### APR1400 Design Certification

RAI No.: 244-8326  
SRP Section: 09.03.03 – Equipment and Floor Drainage Systems  
Application Section: 9.3.3  
Date of RAI Issue: 10/14/2015

### **Question No. 09.03.03-4**

Figure. Turbine Generator Building Drain System

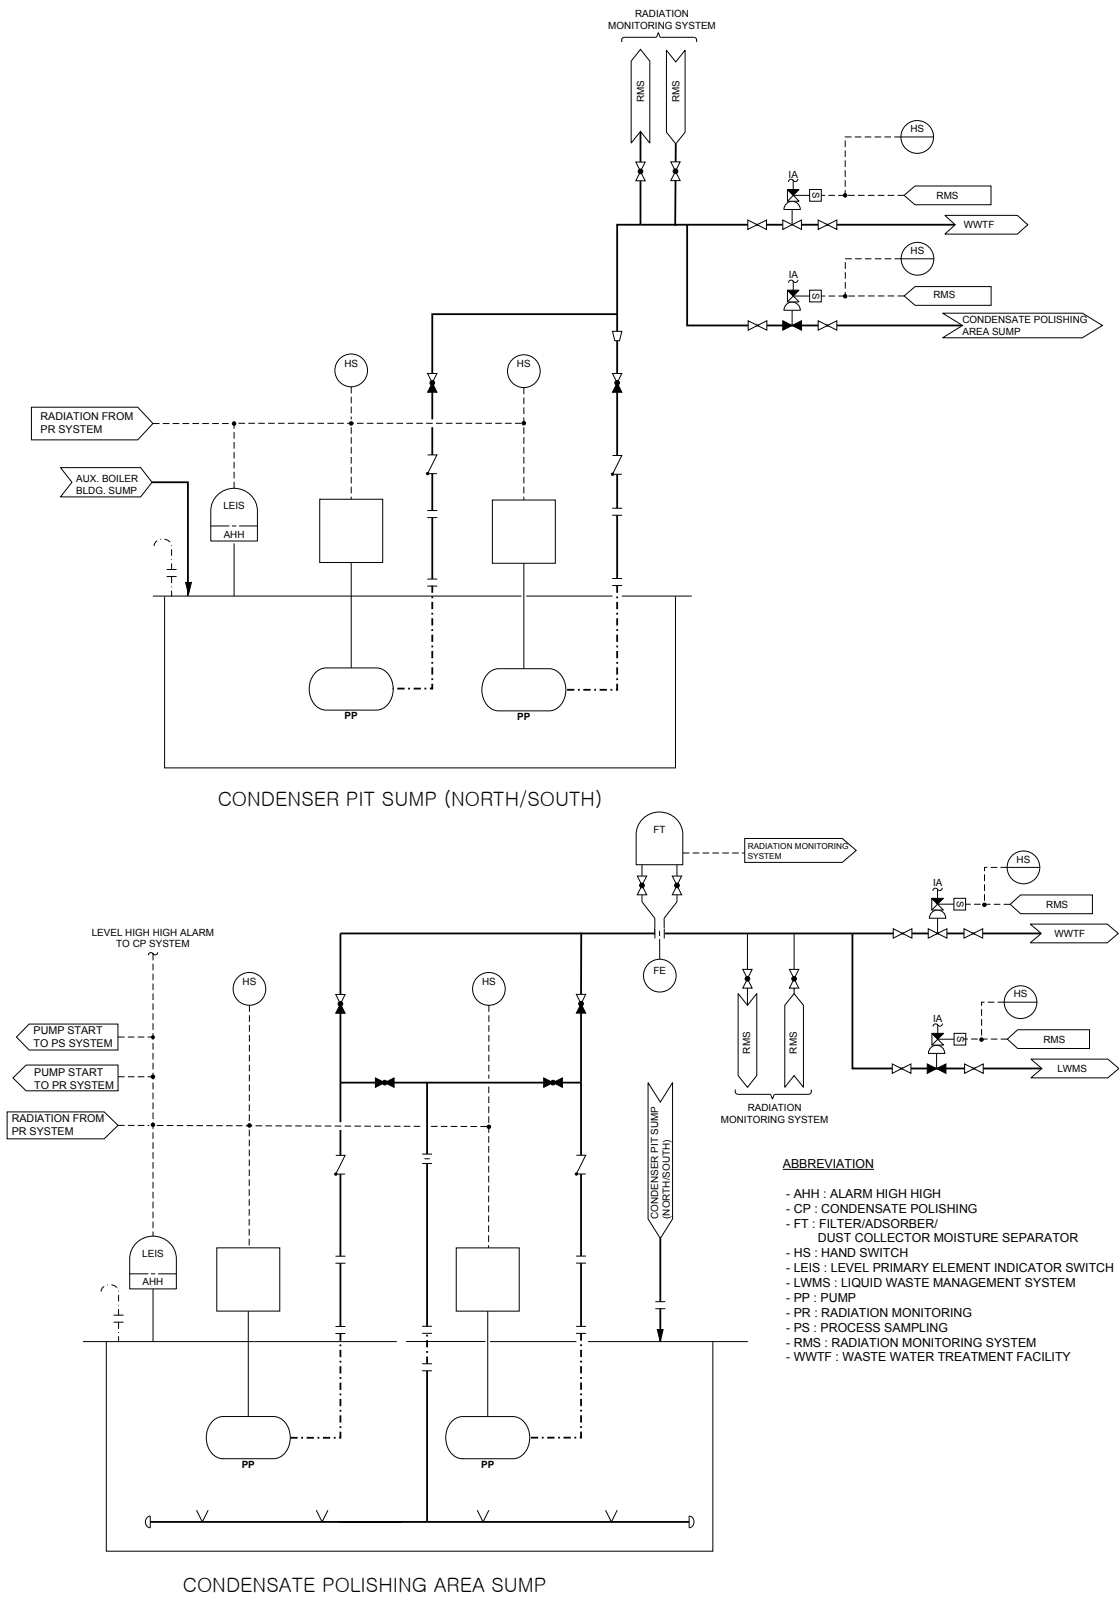
DCD Tier 2, Section 9.3.3.2.2, states that the turbine generating building sump radiation monitors are interlocked with the sump discharge valves to provide proper routing of contaminated fluid. However, the staff is unable to fully determine the operation and circumstances of sump discharge valve operation and thus cannot determine whether the design meets GDC 60 to control suitable releases of radioactive effluents.

The applicant is requested to provide additional information as to how these valves change the flow path in order to conclude whether this is an automatic function or operator action is required.

The turbine generator building drain system consists of condenser pit sumps (north/south) and a condensate polishing area sump. The below figure shows the interconnection of the turbine generator building drain system between the liquid waste management system (LWMS) and the waste water treatment facility (WWTF).

All sump pumps discharge into the WWTF as long as no contamination fluid is present. The discharge from the condensate polishing area sump is monitored for process radiation. Upon detection of radioactivity, the operating sump pump is stopped automatically by the RMS signal. The discharge valve to WWTF is closed, and the discharge valve to LWMS is opened simultaneously. Then, the sump pump is manually started. The flow is then diverted to the LWMS.

The discharges from the condenser pit sumps are monitored for process radiation. Upon detection of radioactivity, the operating sump pumps are stopped automatically by the RMS signal. The discharge valve to the WWTF is closed, and the discharge valve to condensate polishing area sump is opened simultaneously. Then, the sump pump is manually started. The flow is then diverted to the LWMS.

Figure 10.4.10-1 Auxiliary Steam System Flow Diagram (3 of 3)

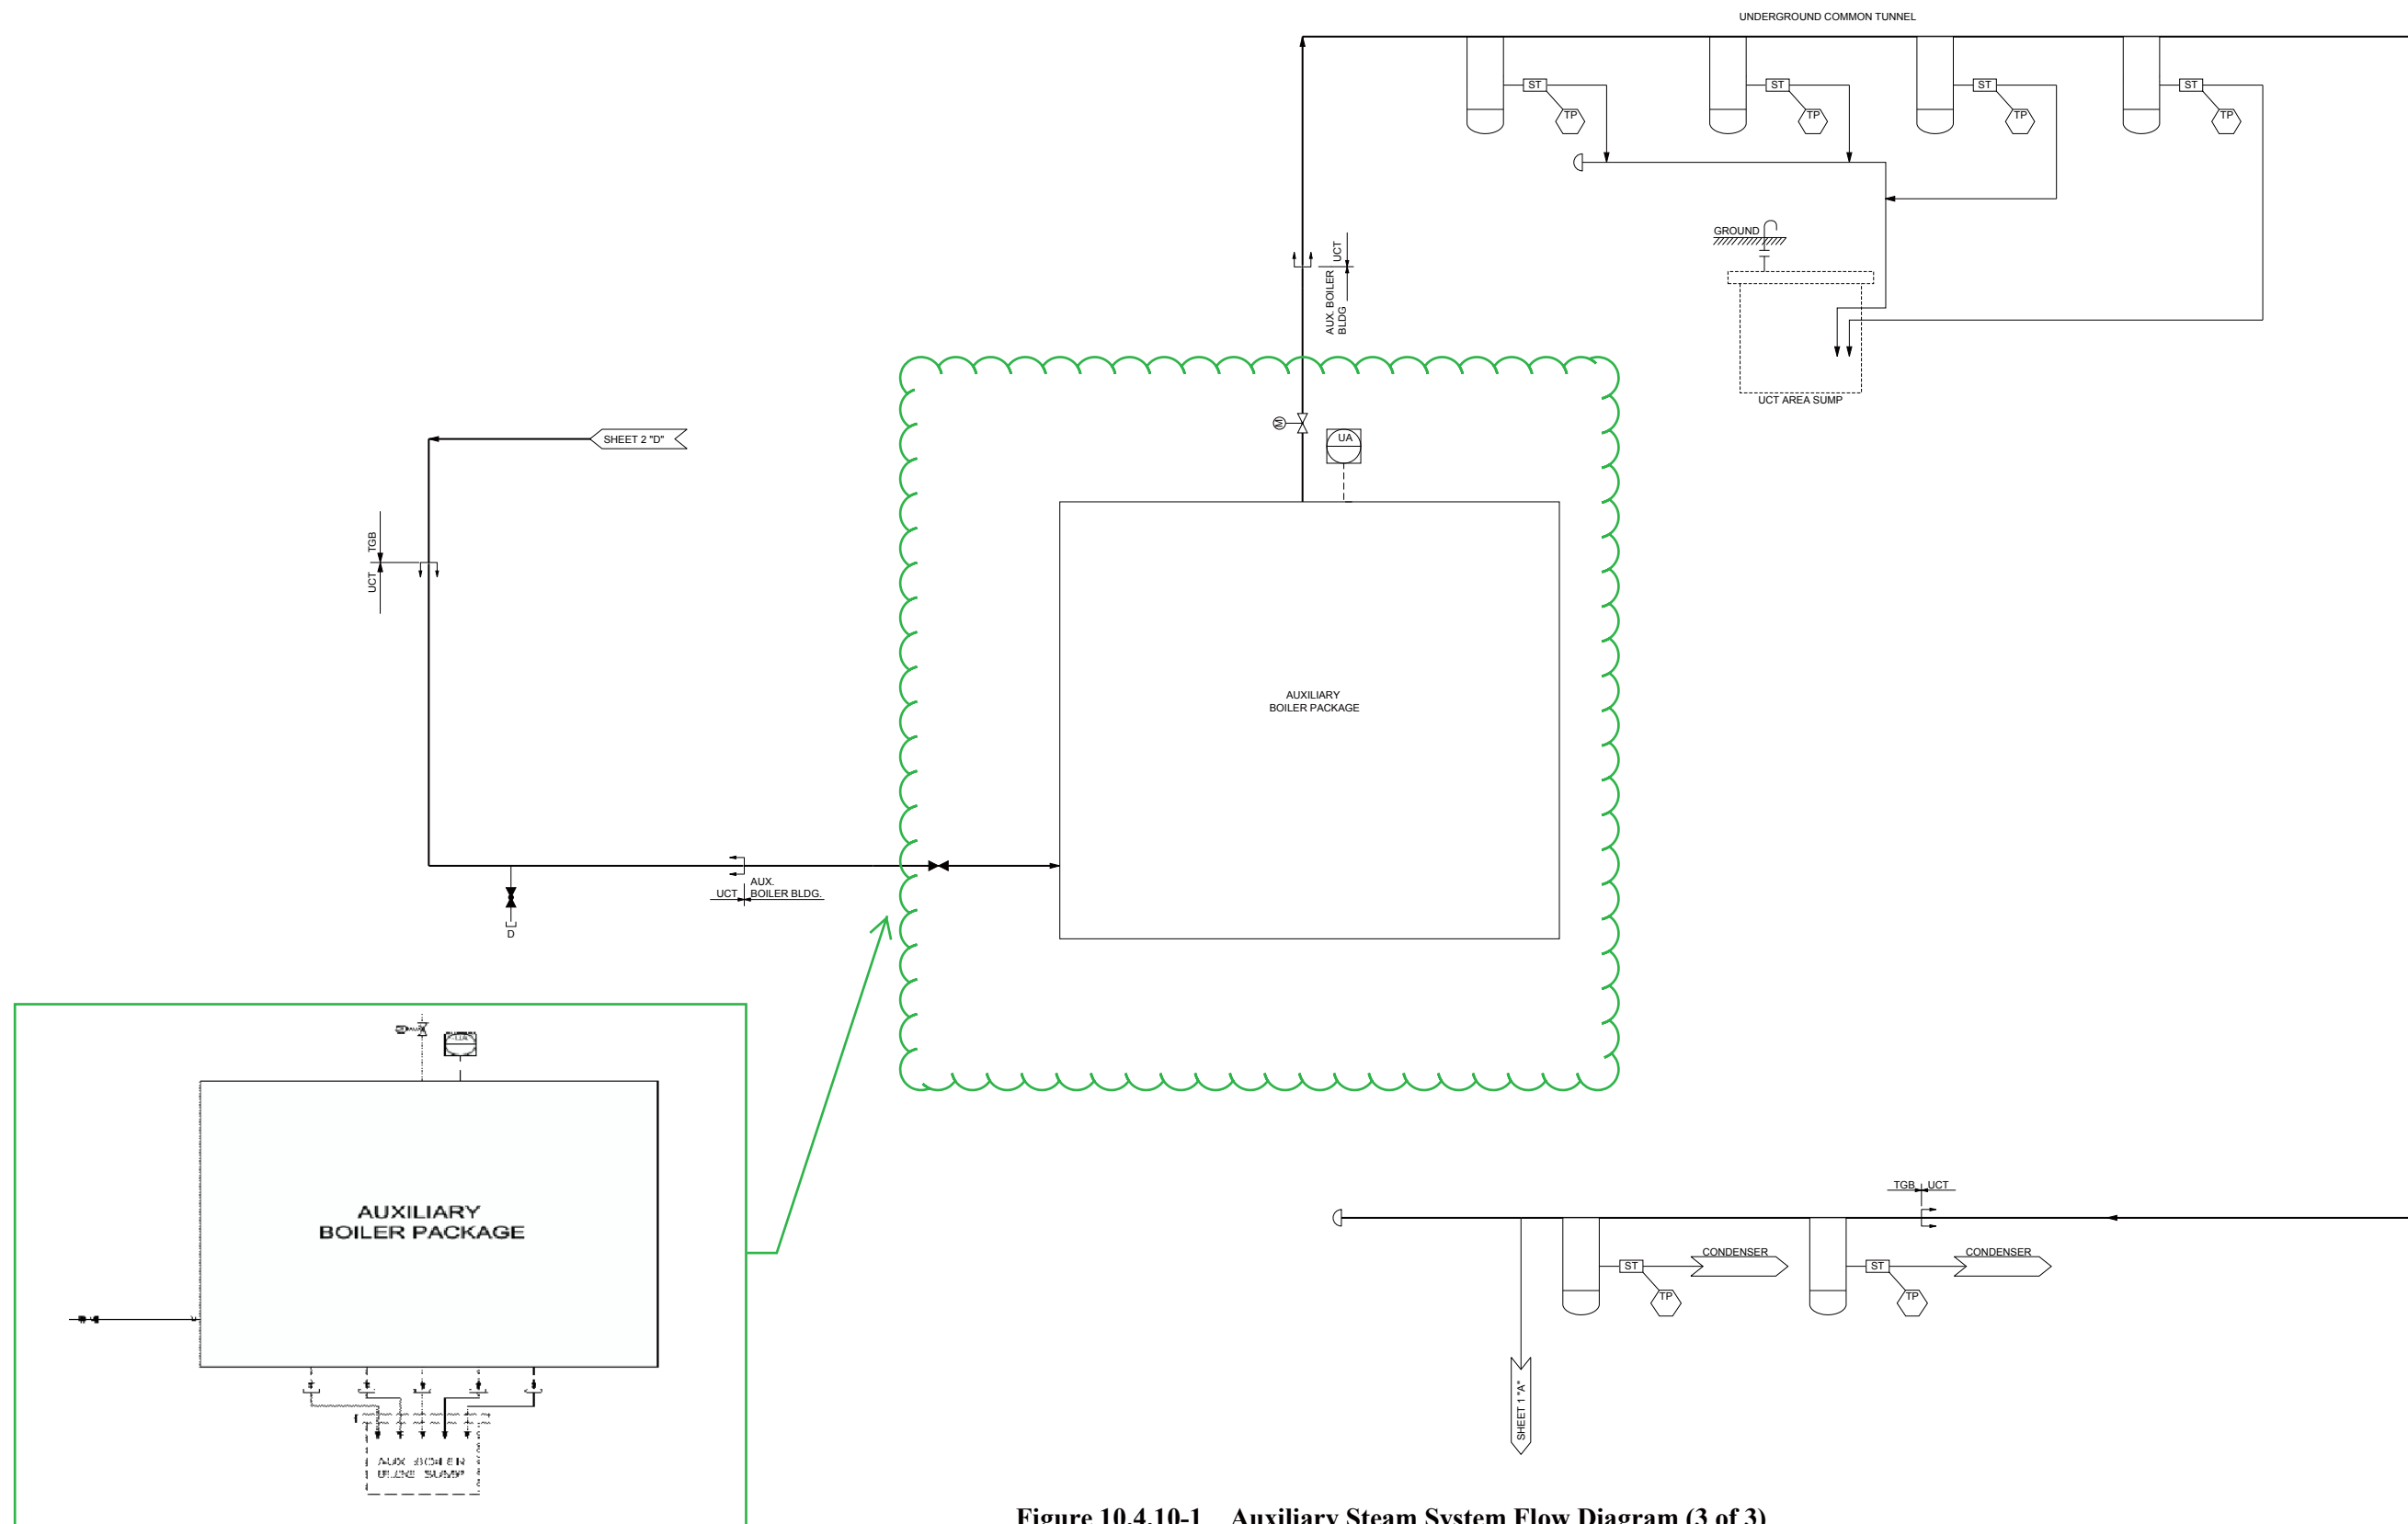
Therefore, DCD Section 10.4.10.2.1 and 10.4.10.2.3 will be revised in accordance with the above description. DCD Tier 2, Figure 10.4.10-1 (Sheet 3 of 3) will include the auxiliary boiler building sump and lines.

c. The Auxiliary Boiler Blowdown and drains are routed to the Auxiliary Boiler Building Sump and then are routed to the turbine generator building (TGB) sump for radiation monitoring. When contamination level of the drains is detected and exceeds a predetermined setpoint, they are routed to the LWMS for processing and release via the condensate polishing area sump.
